SQ Celsius Ltd.

Beraiderchala, Keowa, Maona, Sreepur, Gazipur, Bangladesh.
(24°12'36"N, 90°24'58" E)
3rd June 2014

Structural Inspection Report

Observations & Actions

Extended 2nd floor not shown on drawings

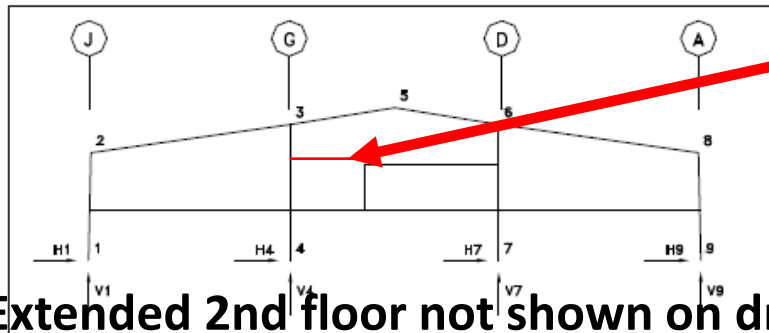
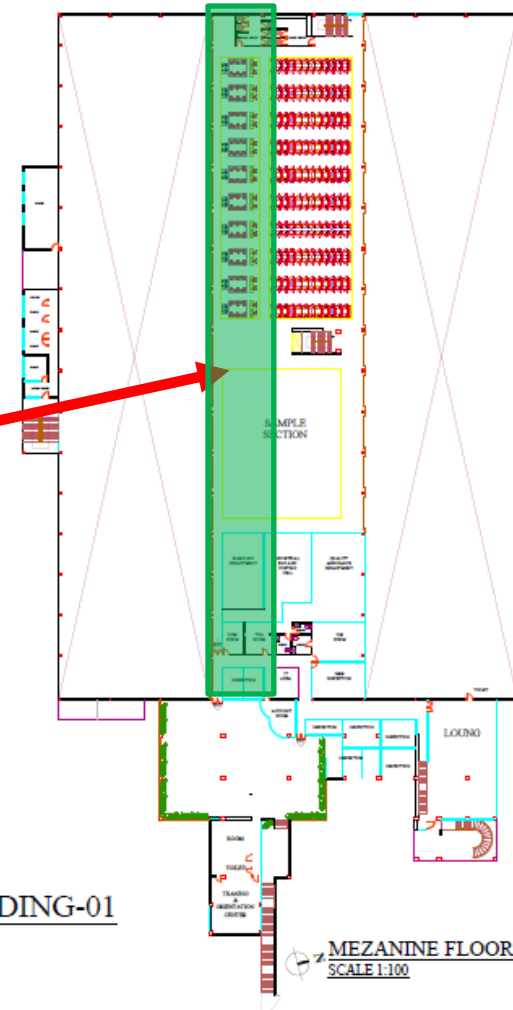
Building Permit shows reduced layout of the 2nd floor (mezzanine) of Production Bulding #1

Extended 2nd floor structure present during factory inspection – changed beams layout

Mezzanine extension not shown on drawings

Differences between the computational model and built

- Factory Engineer to review design, loads and column stresses in area identified above. The current “as-built” structure is more symmetrical, much more regular scheme that shown in the Design.

Non-engineered consoles & hangers

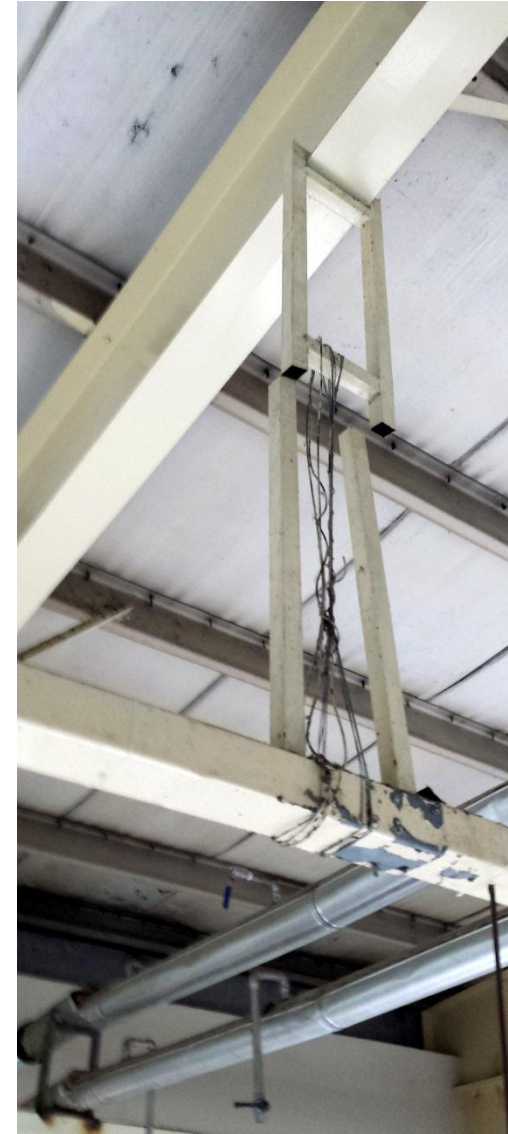
Non-engineered supports

Cracking in masonry walls

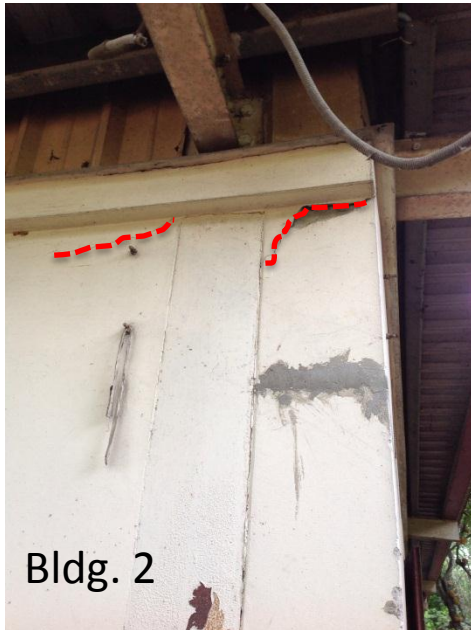
Cracks on the masonry walls. It is recommended to repair and maintain.

Cracks in masonry walls (elevation)

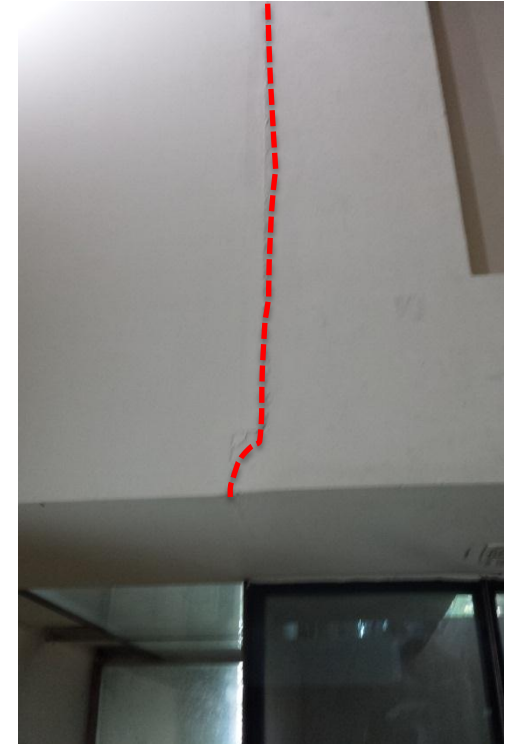
Cracks on the masonry walls.
It is recommended to repair and maintain.

Cracks on the masonry walls.
It is recommended to repair and maintain.

Generator room

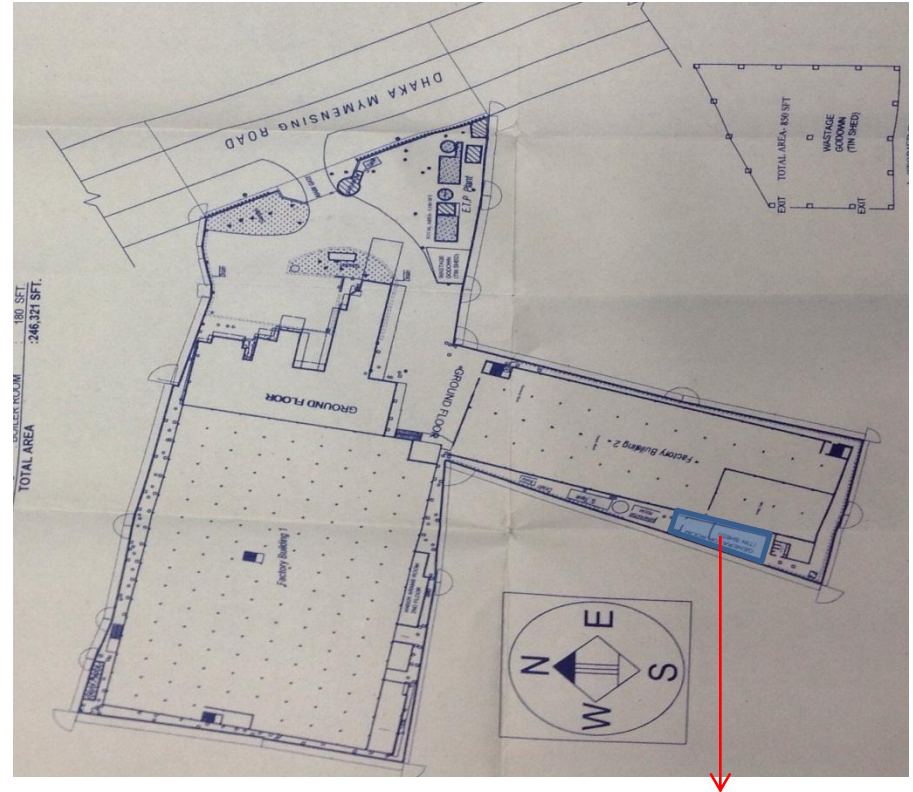
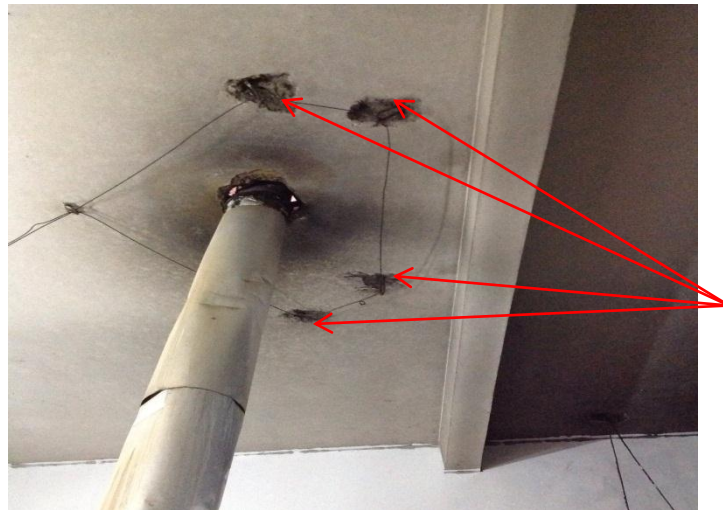
Local cavern in roof slab

Cracks in the generator room.
It is recommended to repair and maintain.

Leakages on the external slab (terraces)

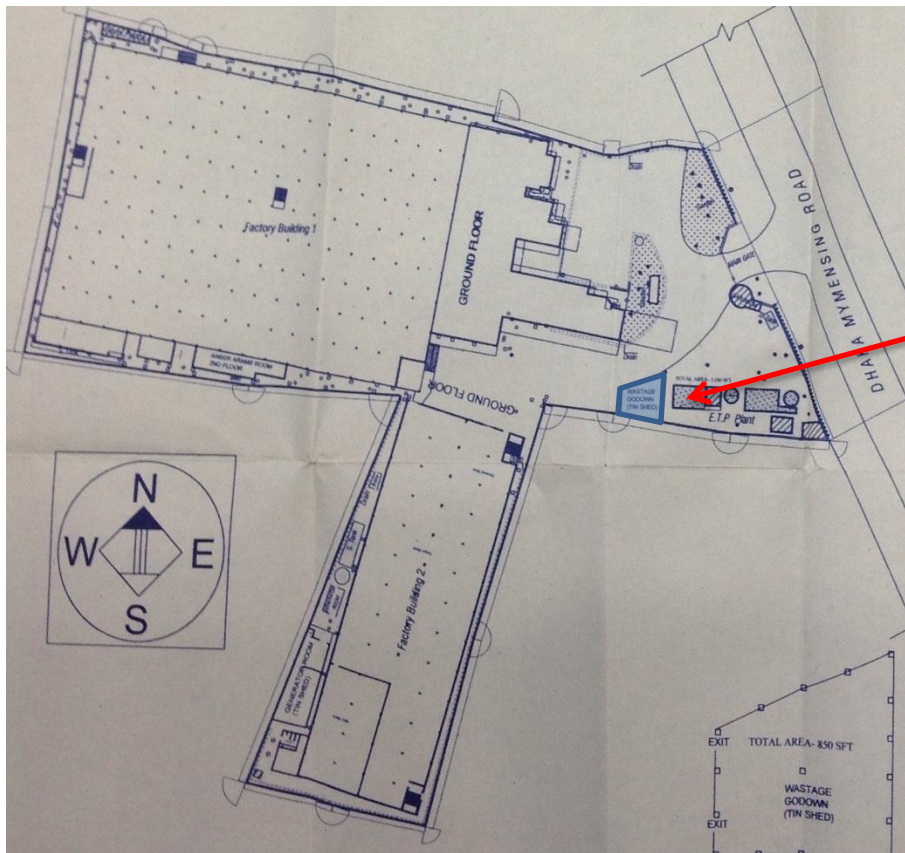
Located on the ceiling leak.
It is recommended to repair and maintain.

- Repair and maintain waterproof of the slab exposed to rain water.
